STATE OF OHIO
 DEPARTMENT OF TRANSPORTATION
HAM US 42 10.07 READING RD
 HAMILTON, WARREN COUNTY
 CITY OF READING

REVIEW COMPLETE

IMPLEMENT TARGET SPEED PILOT PROGRAM COUNTERMEASURES ON US-42 IN THE CITY OF READING INCLUDING A ROAD DIET, ENHANCED CROSSWALKS, RRFBS, RAISED MEDIANS, IN AN EFFORT TO LOWER TRAVEL SPEEDS AND INCREASE VEHICULAR AND PEDESTRIAN SAFETY.

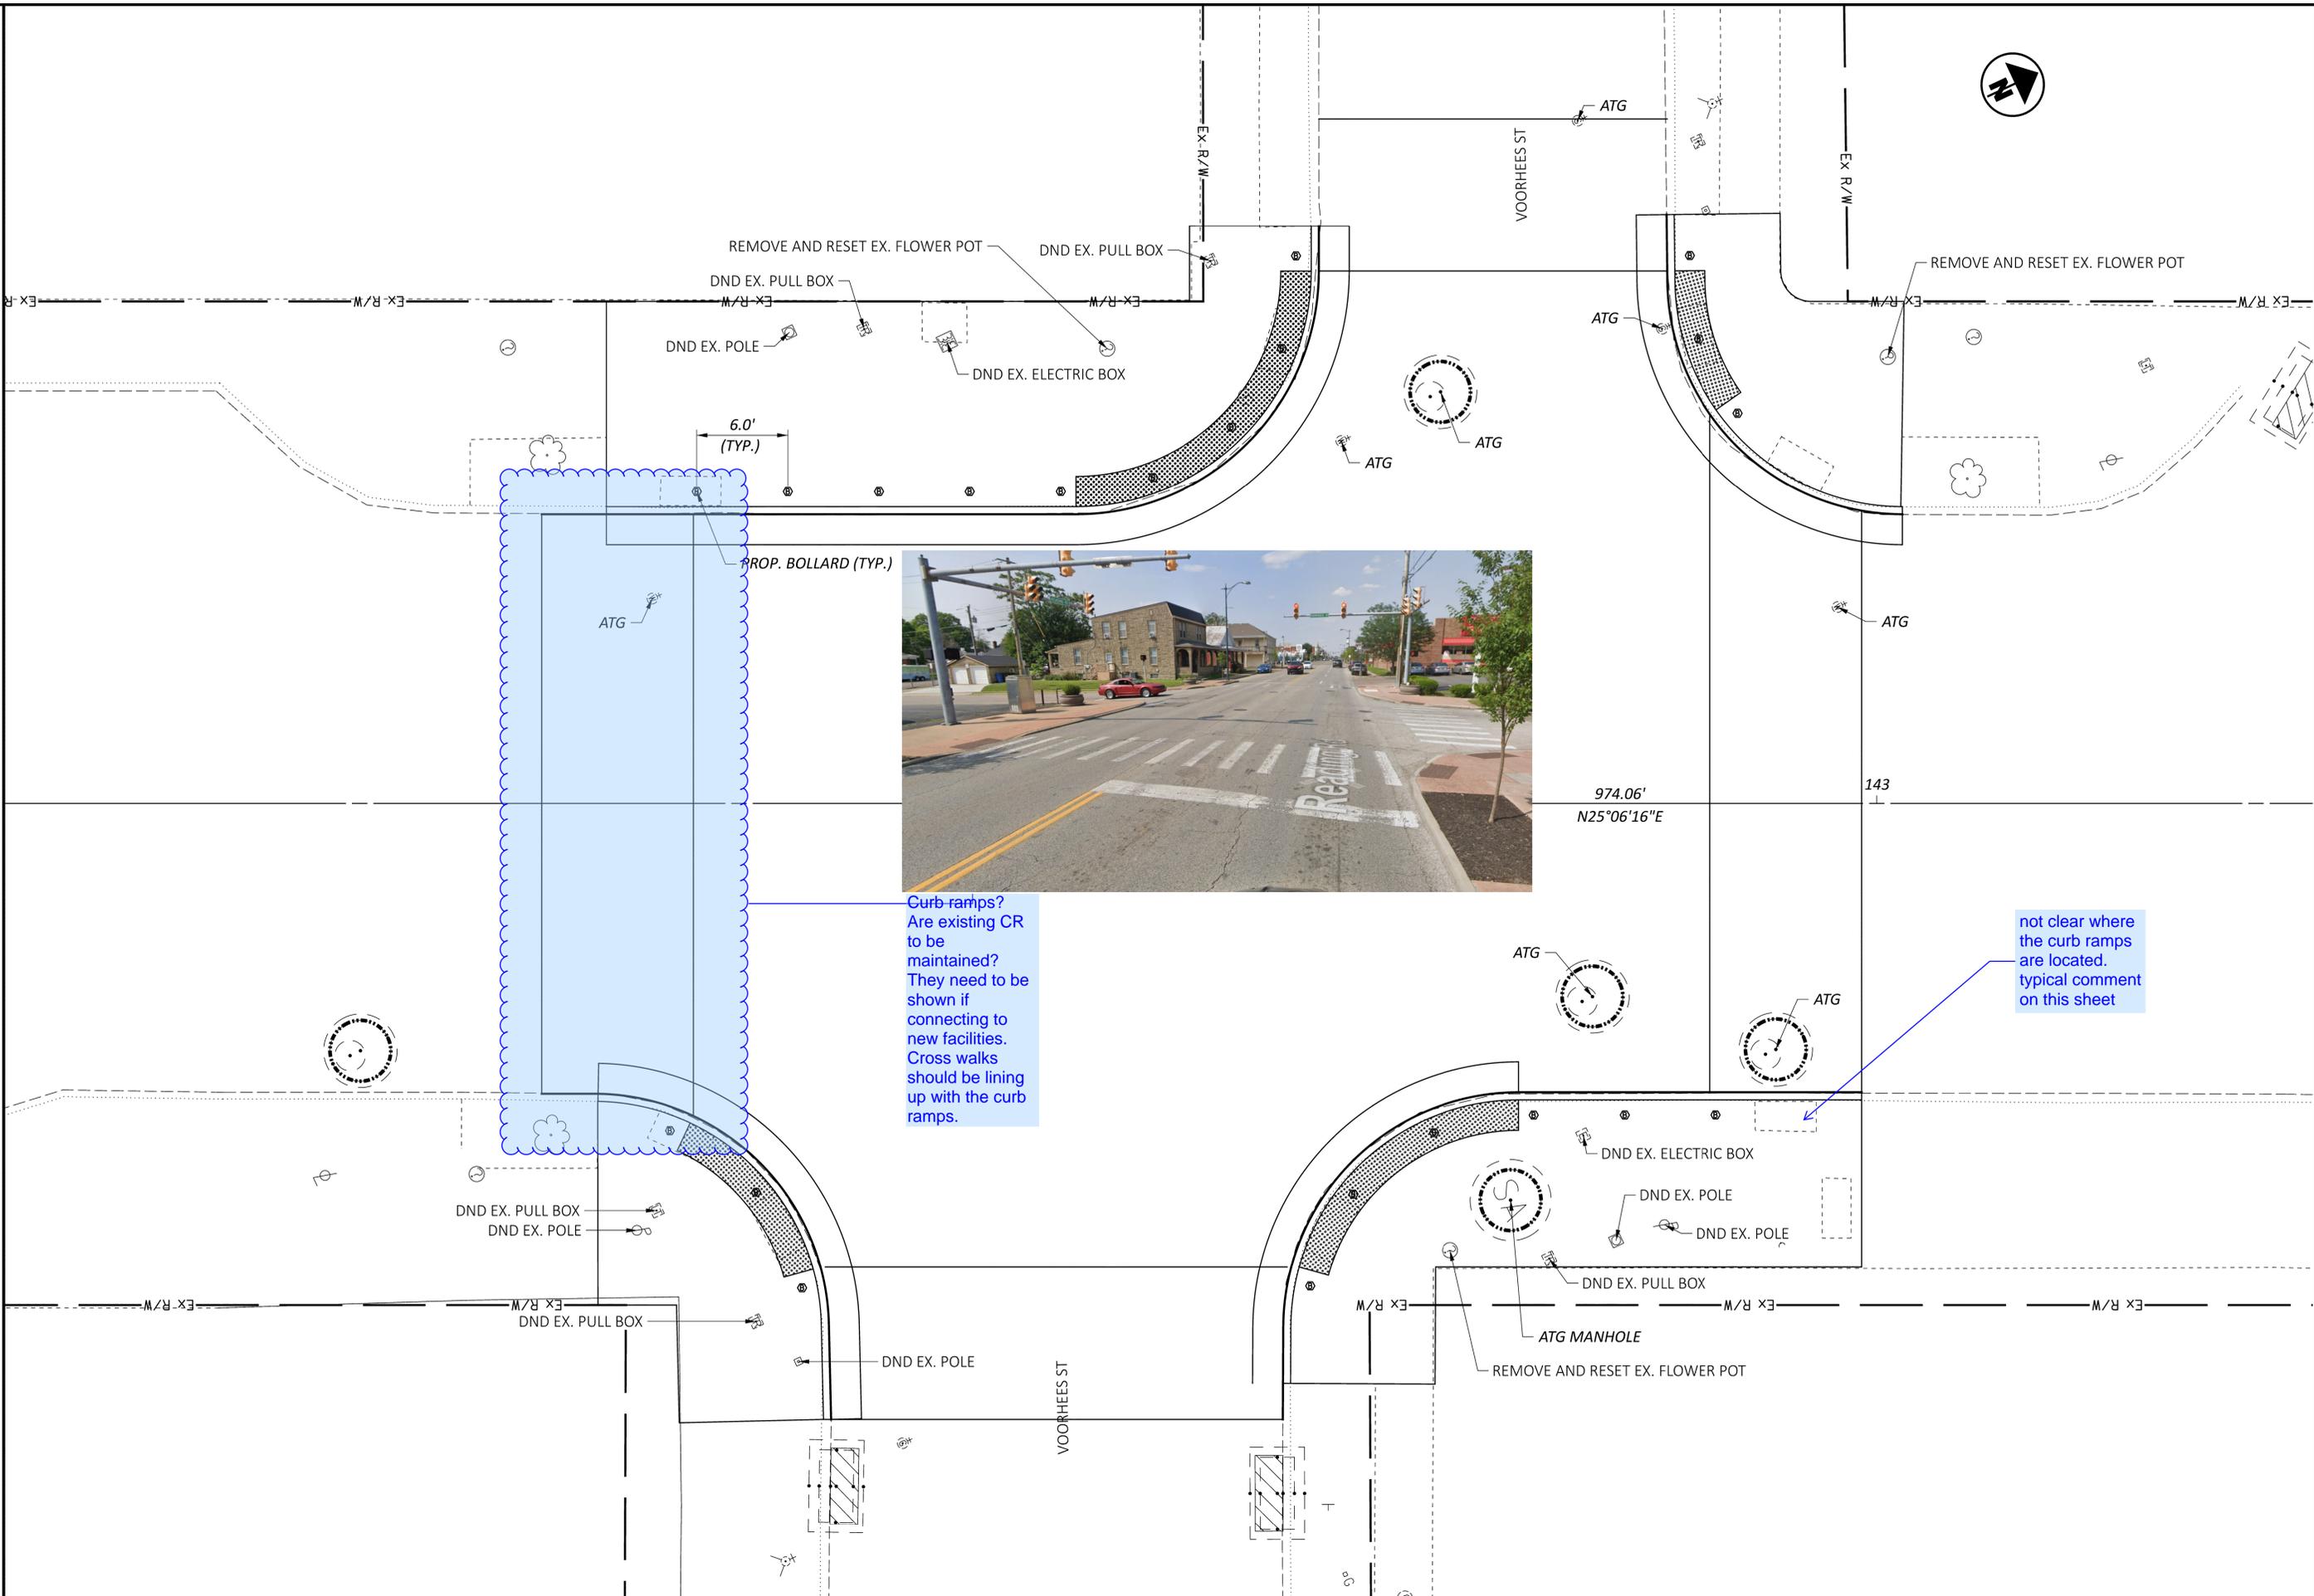
Curb ramps?
Are existing CR
to be
maintained?
They need to be
shown if
connecting to
new facilities.
Cross walks
should be lining
up with the curb
ramps.

not clear where
the curb ramps
are located.
typical comment
on this sheet
